Husky's Response to Board Staff Information Requests for Husky Oil Operations Limited (November 10, 2006)

Fig. 1 Pressure Decline from "Initial" Pressure on Nov 14, 2006

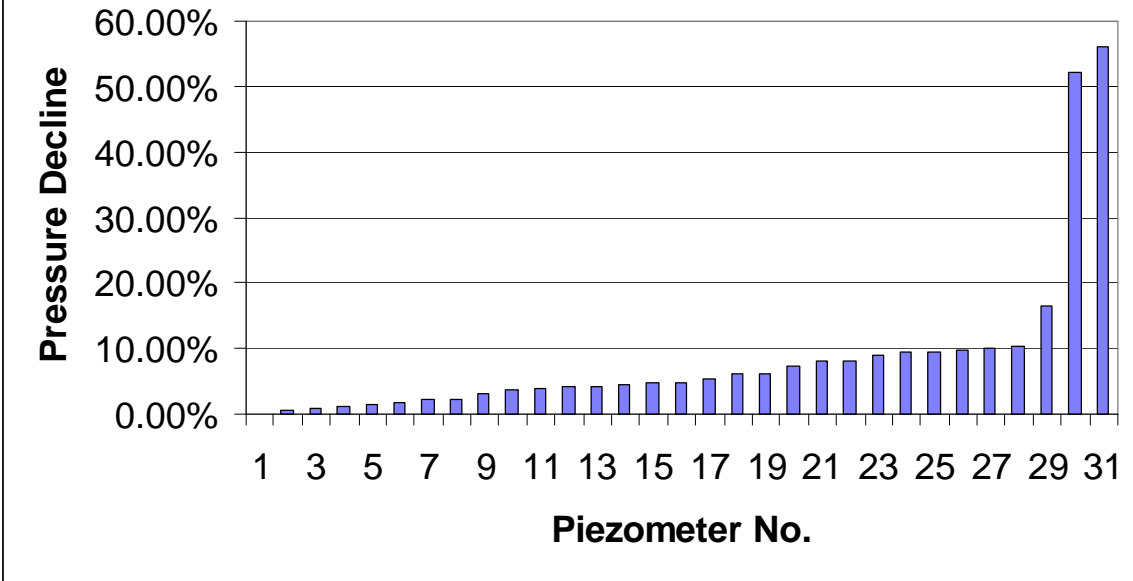
- b) In response 3(c) Husky stated it was evaluating any problems that could explain the pressure anomalies at wells 16-7 and 4-6 where the pressure trends measured by some of the piezometers are decreasing while the pressure trends measured by other piezometers in the same well are increasing. Provide any further explanation for these pressure anomalies that Husky has determined.

Husky's Response: Latest piezometer data to Nov. 14, 2006 is attached. Also shown in Table 1, pressures declines measured at discrete points in time corrected to a datum of +210 mSS using the pressure gradient suggested by EnCana of 9.85 kPa/m. These discrete points are the dates when the data was received from the field. Using this pressure gradient, the initial pressure is calculated as 2808 kPa now (instead of the previously reported value of 2800 kPa with 9.50 kPa/m). Again one should note that this is the highest stabilized pressure observed with the piezometers and it occurs at 472.5 m depth on Aug. 28, 2006 in the 04-06 well. It is also clearly seen that this pressure itself has declined by some amount from the actual initial pressure as evidenced by the declining piezometer pressure trend. Consequently, the pressure decline levels reported in Table 1 are likely to be higher when compared with the actual initial pressure and should be taken as declines observed from the initial pressure observed on Aug. 28, 2006. Note that of all 31 piezometers, 25 (81%) recorded monotonically declining pressures of up to

56% since Aug. 28, 2006. If the two highest points are excluded the mean decline on Nov. 14, 2006 from assumed initial pressure is 5.8% with a standard deviation of 3.8% and a median of 4.6% (see Figure 1). If one looks at the pressure decline during this 2.5 month period alone then the mean pressures decline is 12.6% with a standard deviation of 16.1% and a median of 6.7% (Figure 2). Based on this data, our conclusion is that rapid pressure communication is occurring through out the bitumen zone due to adjacent gas production. Our geological mapping indicates that the top water zone is areally more extensive than both the overlying gas zone in the east and south and the underlying shale zone in the east. The pressure is communicated from the adjacent gas production to the bitumen through two means: (i) pressure transient travels from the gas zone to the top water zone and from there to the bitumen zone laterally and vertically, (ii) where there is no top water zone, pressure transmitted directly from the gas cap to the bitumen vertically and laterally.
